Rezoning Transportation Analysis

Petition Number: 2020-038

General Location Identifier: Tax ID 20143102

Date	Description
04-22-2020	First Review (EL)
05-19-2020	Second Review (EL)
06-25-2020	Third Review (EL)
08-20-2020	Fourth Review (KP)
09-17-2020	Fifth Review (KP)

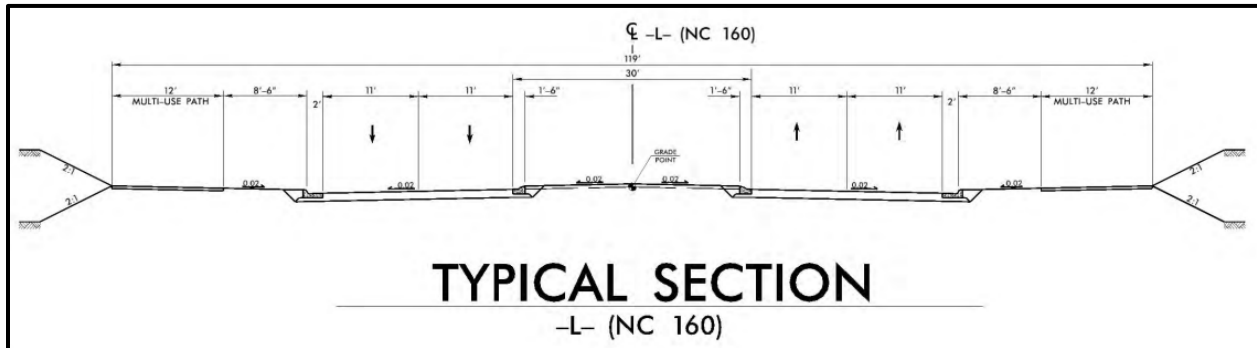
1. ~~**Curblin**~~ The proposed zoning district has a setback measured from back of the existing or proposed future curblin.
 - a. ~~**Steele Creek Road:**~~ Location of curb and gutter needs to be shown on the plans based on the NCDOT TIP Project (U-5766) NC 160. The curb and gutter doesn't need to be constructed, but it does need to be shown on the plans.

The site plan should show the curb and gutter labeled and dimensioned from the centerline for each road.
